TECHNICAL BULLETIN #98

Item #1 - Icon Containers with Skyhook Installed

Item #2 – Substandard Loop Washers

Item #3 – Mandatory Cutter Replacement Period Extended

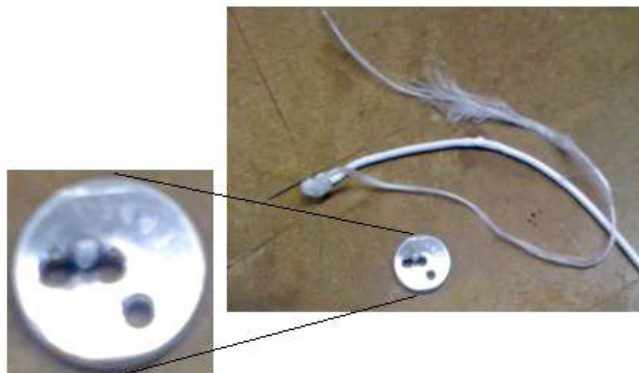
Aerodyne has become aware of recent instances in which a Skyhook Icon container was incorrectly packed with the main risers misrouted under the reserve tab causing a riser cover to not release the main riser when the main was deployed. During testing it was also found that some combinations of components (rig sizing, reserve size, etc.) could potentially result in an incomplete riser deployment when deploying the reserve during a total malfunction.

This is a mandatory recall of all Icon containers with Skyhook option manufactured prior to January 14, 2011.

Aerodyne has modified and tested an updated riser tuck tab design to prevent these occurrences and has as a general update and safety measure decided to implement this design in all Icon equipment with a Skyhook.
